# #3033076-LU

1417 E HOWELL ST ADR: RECOMMENDATION PACKET

1417 E HOWELL STREET  
SDCI# 3033076-LU

ENLARGED PLAN - CENTRAL WALKWAY

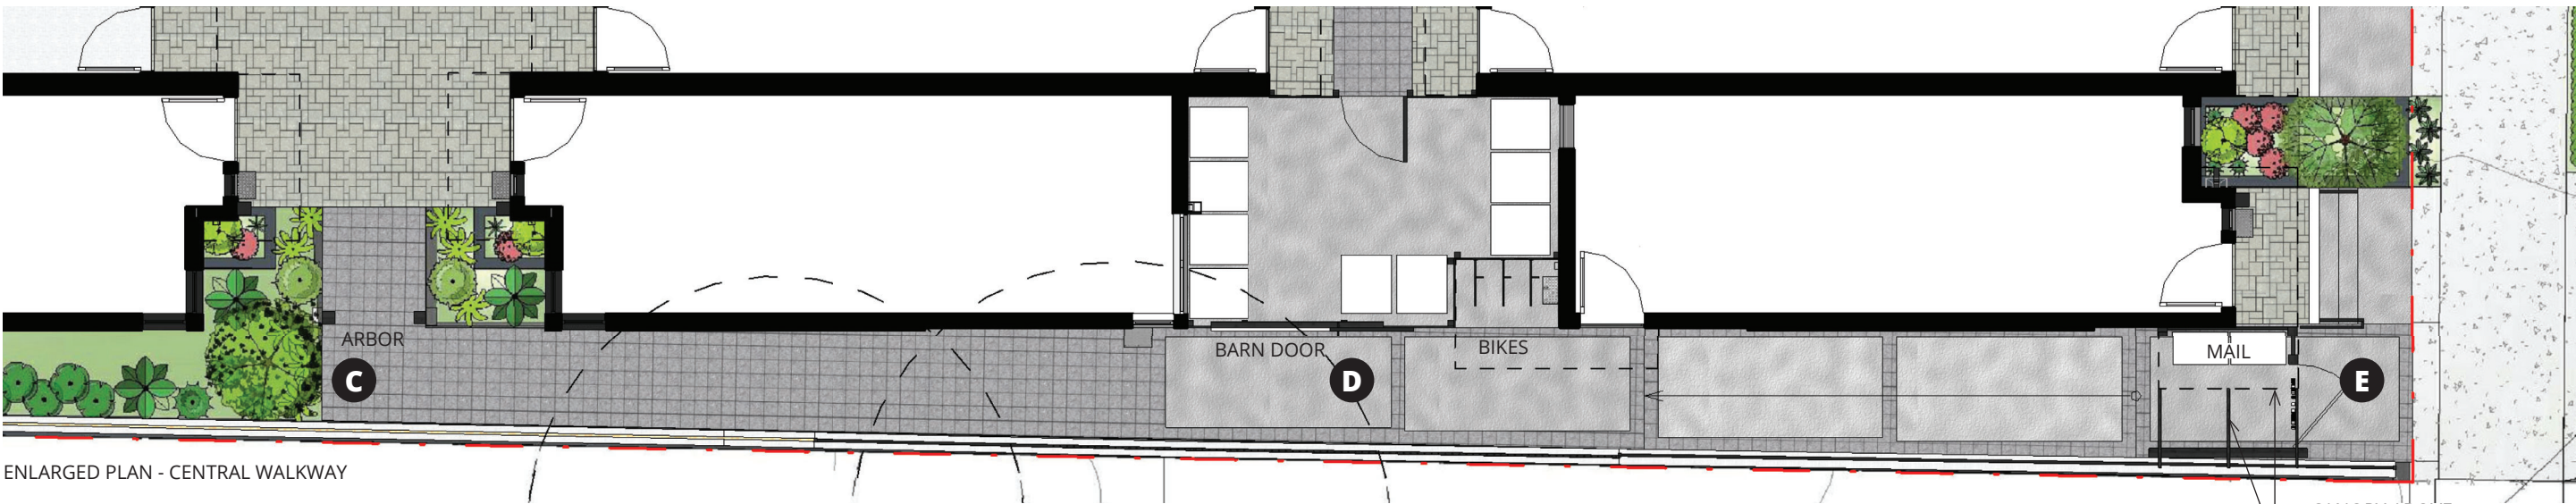
| BOARD FEEDBACK/GUIDANCE  | APPLICANT RESPONSE  |
|--|---|
| <div><div>2</div><div><div>OPEN SPACE AND SITE PLANNING</div><div><b>2A) OPEN SPACES</b><br/>Staff is concerned about the design and viability of the shared open spaces and circulation areas. For Recommendation phase of review, please provide complete orthographic drawings as well as perspectives, axonometrics, etc. demonstrating the character of these spaces.</div></div></div>   | <div><div>2</div><div><div>OPEN SPACE AND SITE PLANNING</div><div><b>2A) OPEN SPACES</b><br/>Open spaces have been further developed and widened. Please note that 100% of the required Amenity Area is met at grade, not including roof decks, exceeding the 50% as required per code. These amenity areas are carefully designed for user interaction. See page 11 and 19-20.</div></div></div>   |

- Shared open spaces and circulation areas have been further developed with landscaping, lighting, paving, and gates/fencing.
- The entry from the street is identified by an 8'-6" black stained wood trellis with a metal gate. Mailboxes and signage further define entry to the site. The canopy from Unit A.1 extends to cover the mailboxes, then the framing continues out to form a structure for the entry gate. Addresses for Building B and C are cut into the mesh infill of the entry gate. The gate acts as a filter rather than a barrier, providing a layer of security while maintaining visual transparency.
- A black stained fence encloses the trash storage area and bike parking.
- A black stained wood arbor frames the entry to the courtyard.

CONCEPT DEVELOPMENT: ENTRIES

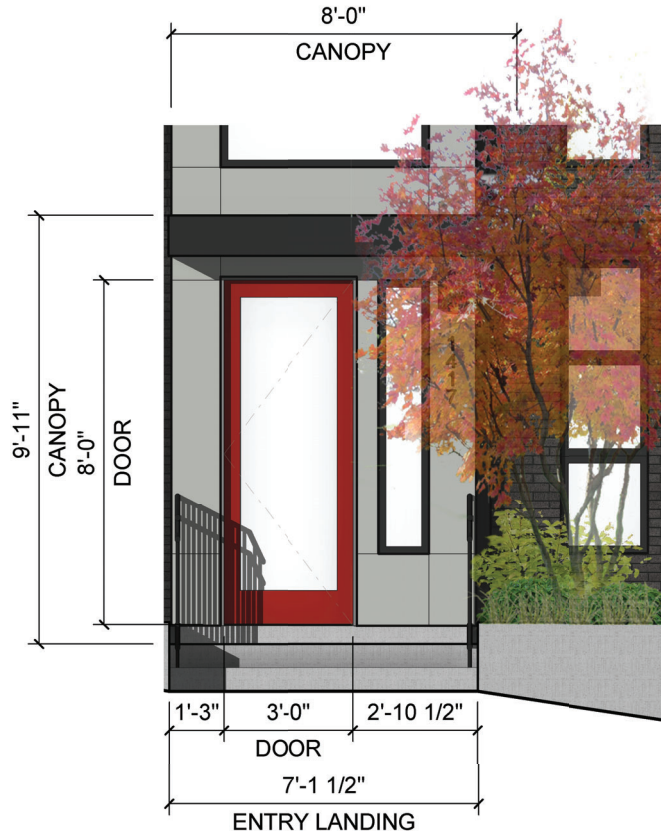
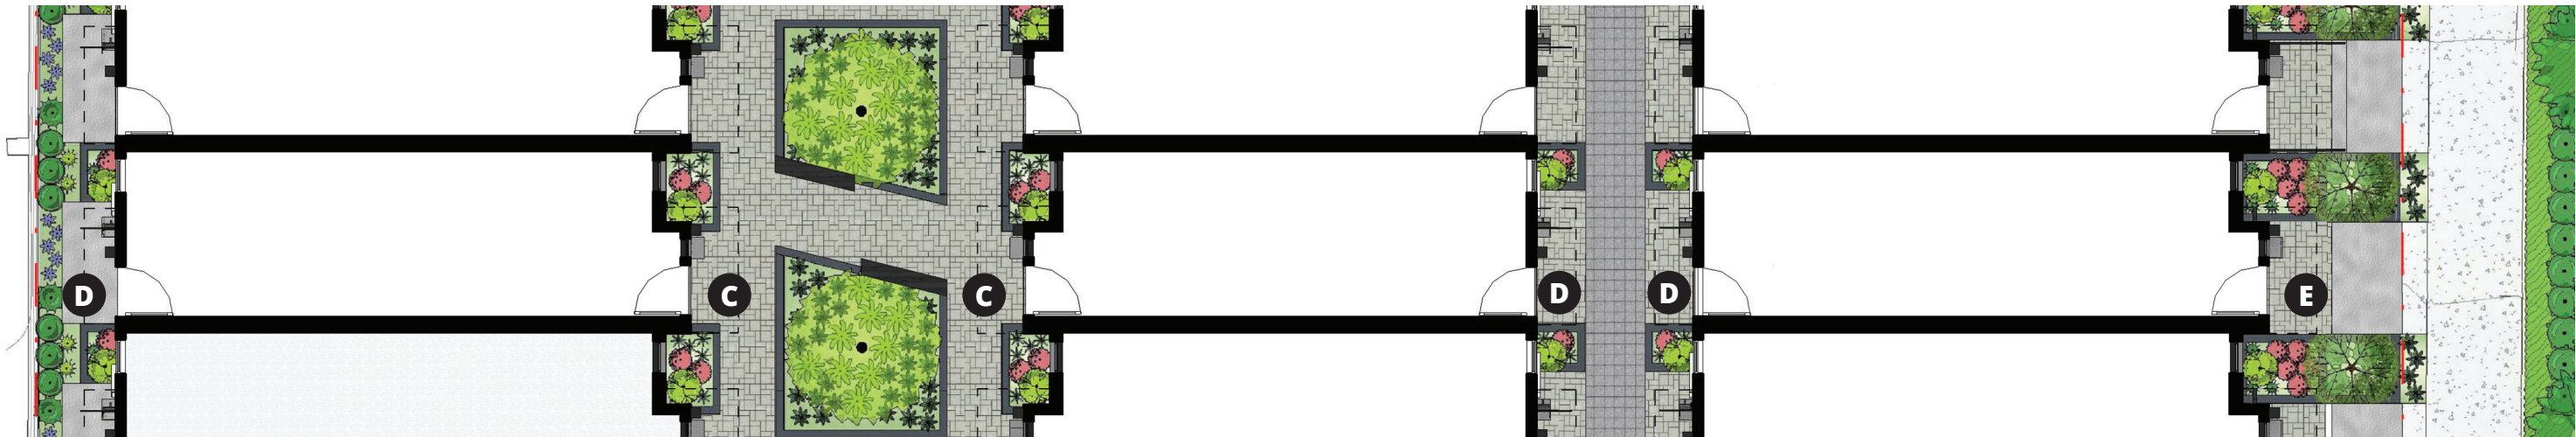
| BOARD FEEDBACK/GUIDANCE  | APPLICANT RESPONSE  |
|--|---|
| <div><div>5</div><div><div>RESIDENTIAL ENTRIES</div><div><b>5A) ENTRYWAYS (PL2-II)</b><br/>In the preferred scheme, 10 of the 15 units are accessed via a shared walkway at the east edge of the site. As such, the entry 'portal' from the street should have significant street presence and be developed architecturally (as well as with signage) to be welcoming and identifiable as a gateway.</div><div><b>5B) INDIVIDUAL ENTRIES (PL3-A-3)</b><br/>Individual entry areas should incorporate elements in the ground plane and overhead, be appropriately scaled (5% of unit size, for example), gracefully proportioned, and include secondary elements that support the design. Clearly identify these elements in future drawings.</div><div><b>5C) DESIGN OBJECTIVES (PL3-A, PL3-B, DC2-B, PL3-A-1, PL3-A-2, AND PL3-A-4)</b><br/>At the street-edge it is particularly important to develop all exterior areas as usable and understandably part of the experience of the townhouse entry.</div></div></div> | <div><div>5</div><div><div>RESIDENTIAL ENTRIES</div><div><b>5A) ENTRYWAYS (PL2-II)</b><br/>An entry arbor and gate create an entry vestibule that coheres with the building's material palette and is easily identifiable from the street. See pages 10, 14, and 19.</div><div><b>5B) INDIVIDUAL ENTRIES (PL3-A-3)</b><br/>5% of a unit ranges between 50 sf and 60 sf, and this project provides entry areas between 50 sf to100 sf, depending on location fo each unit. Entries include stairs, planters and stoop. 7' wide stairs create a gracious entry and tie the site improvements to the overall massing of the project. Canopies are provided over the red doors. The collection of elements creates a highly visible and welcoming entry while maintaining a strong street frontage. See pages 11, 18, and 21.</div><div><b>5C) DESIGN OBJECTIVES (PL3-A, PL3-B, DC2-B, PL3-A-1, PL3-A-2, AND PL3-A-4)</b><br/>Exterior entries landings were expanded to provide up to 2'-10" to the side of the door for plants or a chair. Overhead weather protection is provided. Planters have been designed to step down to the street so a wall along the street is not created. See pages 14, 18, and 21.</div></div></div> |

- Two primary entry conditions occur at the street and at the courtyard, both identified by address numbers, lighting, a canopy, and planters.
- Street entries have large areas of glazing and are accessed by an entry stoop that steps up or down from E Howell St.
- Courtyard entries have large areas of glazing and are accessed by a landing off the courtyard.
- Each unit has a back door that opens onto to a small landing with a bike rack, canopy, and lighting.

# CONCEPT DEVELOPMENT: FORM & MATERIALITY PROPOSED

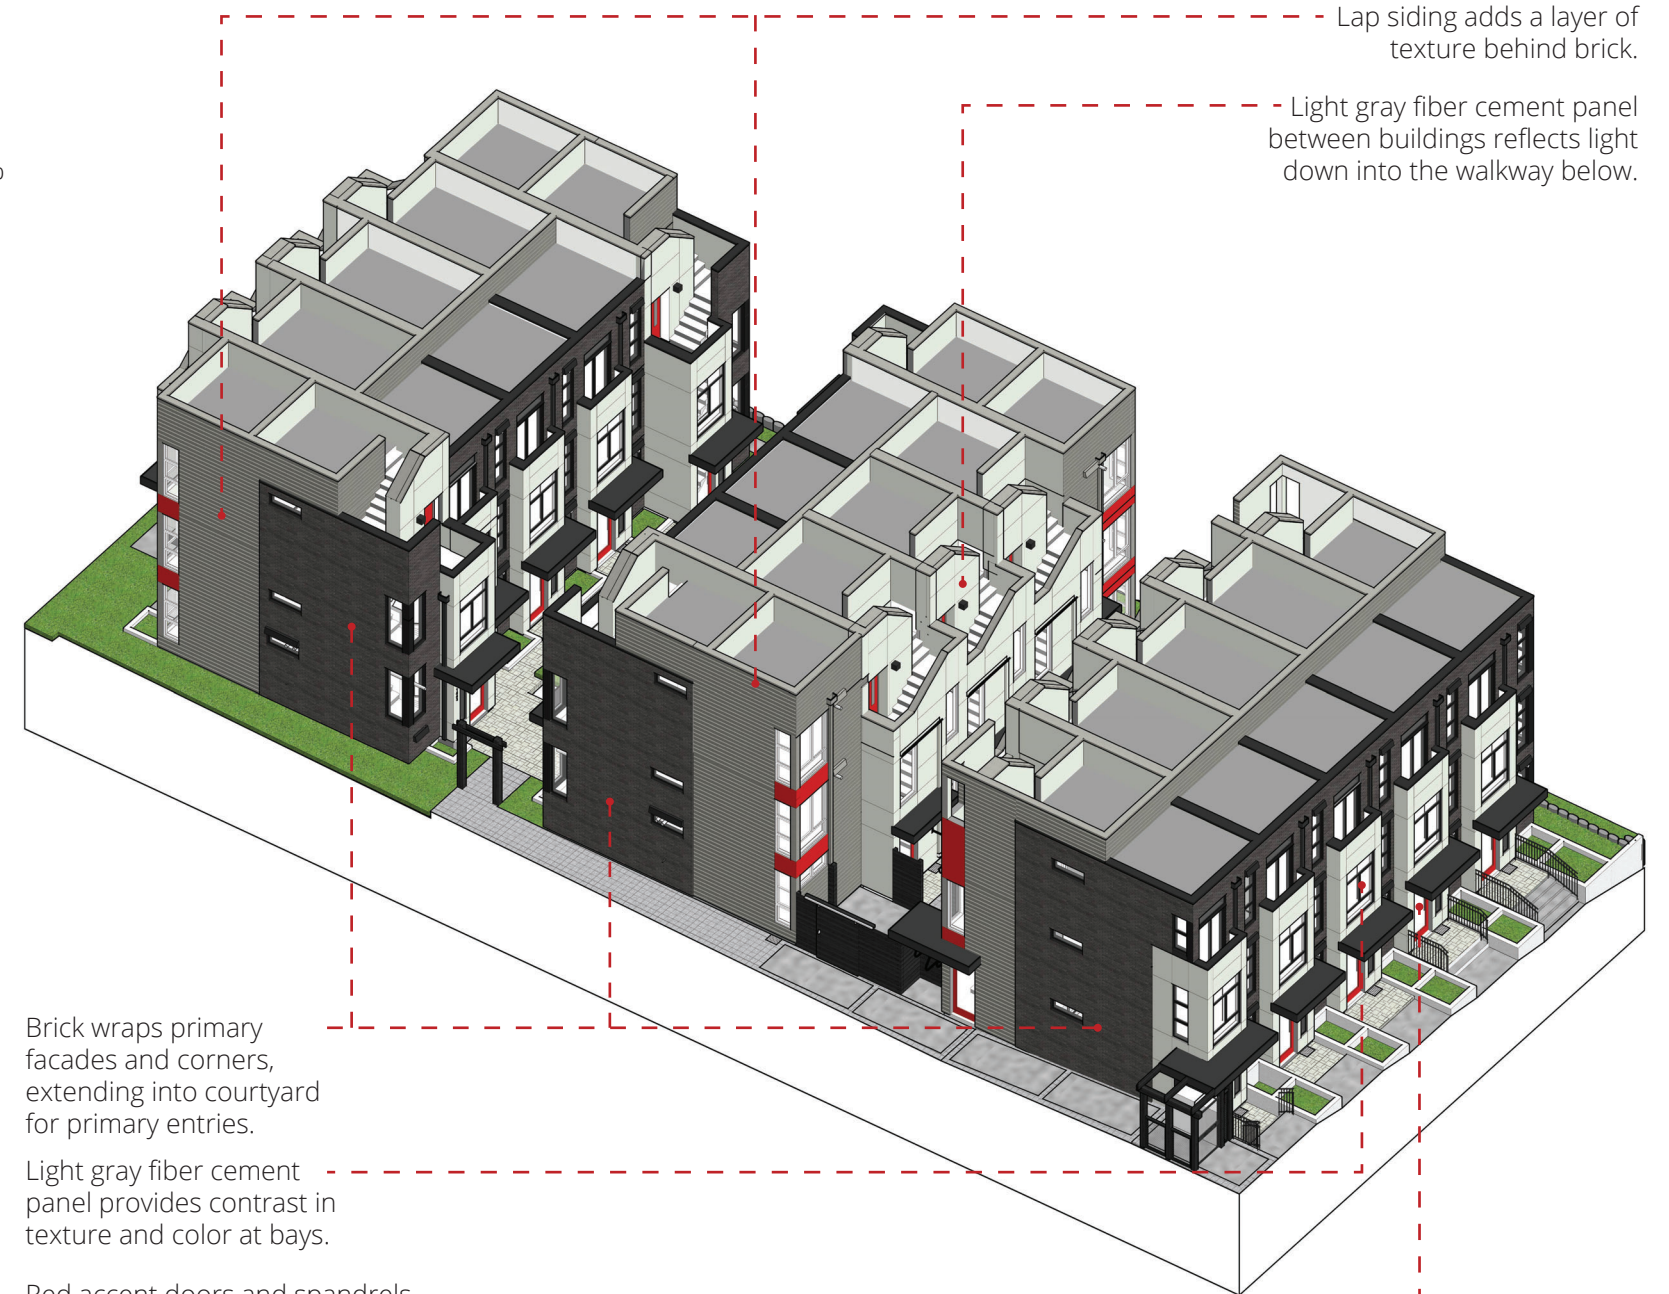
| BOARD FEEDBACK/GUIDANCE  | APPLICANT RESPONSE  |
|--|---|
| <div><div>3</div><div><div>DESIGN CONCEPT</div><div><b>3A+B) TOPOGRAPHY (CS1-C, DC3-I-ii, CS2-A, DC3-I)</b><br/>While staff agrees that Scheme C has the potential to meet the criteria in the Design Guidelines, staff encourages the applicant to explore variations that connect more directly to the topography of the site and its immediate context and offer the following as a few options, among the myriad possibilities. (CS1-C, DC3-I-ii, CS2-A, DC3-I)</div></div></div>  | <div><div>3</div><div><div>DESIGN CONCEPT</div><div><b>3A+B) TOPOGRAPHY (CS1-C, DC3-I-ii, CS2-A, DC3-I)</b><br/>The uniform organization makes the project strong and clearly identifies each unit separately. This project is a formal expression of units that is distinguishable from apartment buildings. With 5 units, a non-uniform pattern would diminish the overall concept. See pages 22-23.</div></div></div>  |

- Two-story light gray fiber cement panel bays project from a brick facade.
- Fiber cement panel joints align with fenestration layout.
- Entries are differentiated from rest of the facade by massing and materiality.
- NOTE: Based on Planner feedback on REC draft, the front parapet height was reduced by 6" and entry side lite height increased by 8".**

- Brick (37%) and glazing (39%) comprise 76% of the front facade, with fiber cement panel covering only 24% of the front facade. Combination of brick and black vinyl windows results in a majority of the facade being a high quality material.
